April 11, 2019

Peter Walden
Martin County Growth Management
2401 SE Monterey Road
Stuart, FL 34996

**Re: West Stuart Business Center Revised Major Final Site Plan
Response to Comments, # E016-036, DEV2018110010**

5 BUILDING 4 SOUTH ELEVATION-PRIMARY FACADE

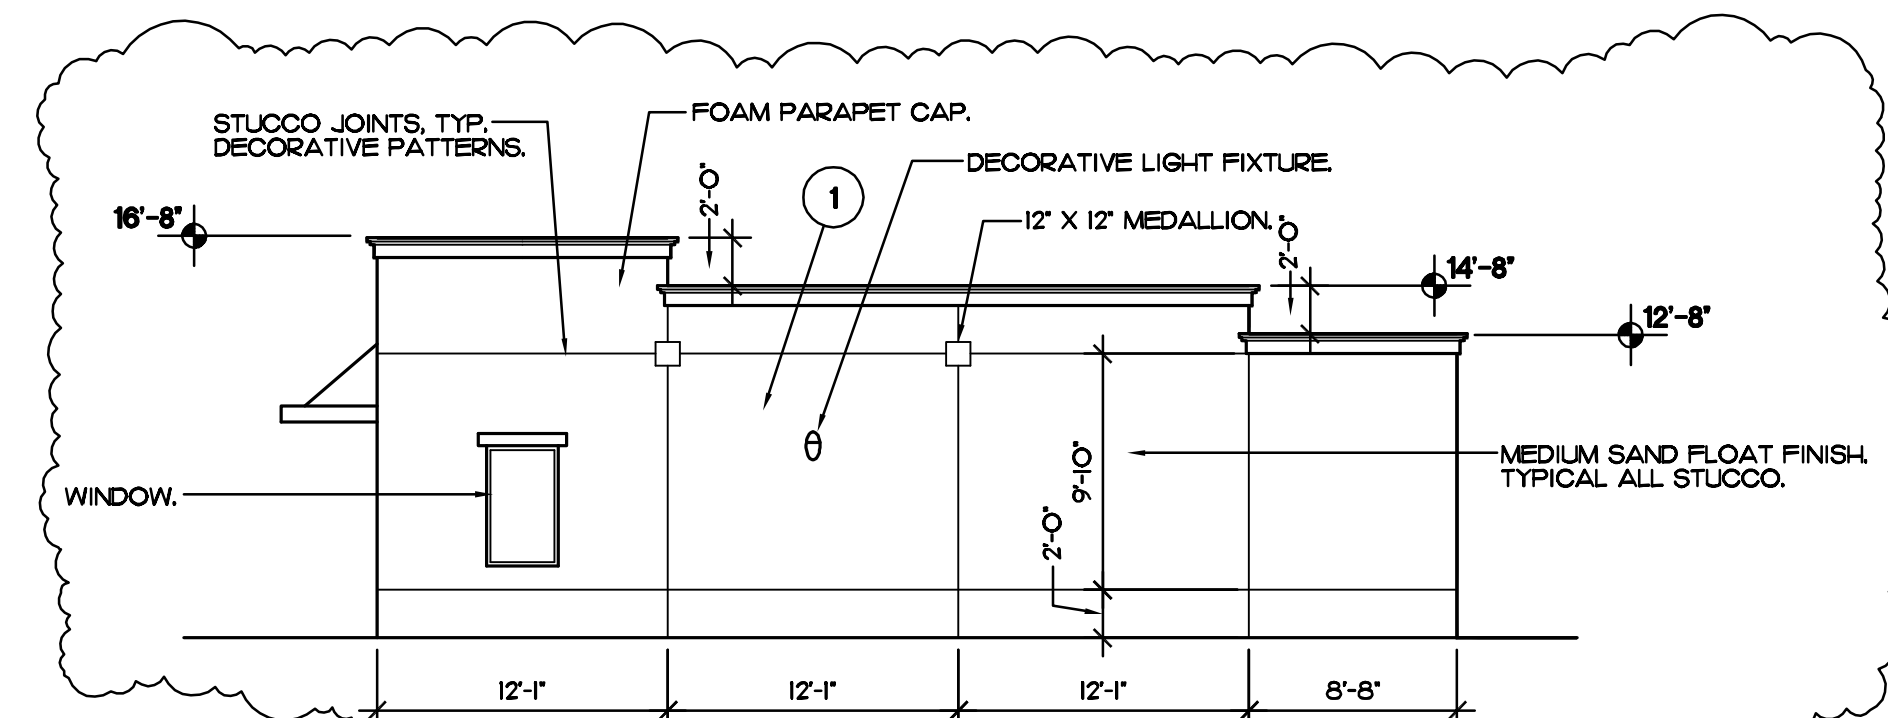
The South Façade of Building 4 has only three design features. Please show on the South Elevation Façade of Building 4 one additional design feature.

The South Façade of Building 4 shows a blank wall area that exceeds 10 feet in vertical direction and 20 feet in horizontal direction. Please include on the blank wall one additional design feature from the list of Section 4.872.C.2.

The South Façade of Building 4 does not have at least two changes in height. Please provide one additional change in the height along the South Façade of Building 4. Please submit an architectural detail showing the required cornice treatment along the entire length of the primary facades.

RESPONSE: The south façade of Building 4 has the following four design features: 1) Window, 2) Decorative light fixture, 3) Foam medallions, 4) Stucco reveal joints in a decorative pattern. See Sheet A4.1, Drawing 5, Revision 2.

RESPONSE: *The south façade of Building 4 has stucco reveal joints indicated in decorative patterns. The patterns have been dimensioned to indicate there are no blank wall areas greater than 10' in vertical direction and 20' in horizontal direction. See Sheet A4.1, Drawing 5, Revision 2.*

RESPONSE: *The south façade of Building 4 has been revised to indicate two changes in parapet height. See Sheet A4.1, Drawing 5, Revision 2 and Sheet A4.2, Drawing 4, Revision 2.*
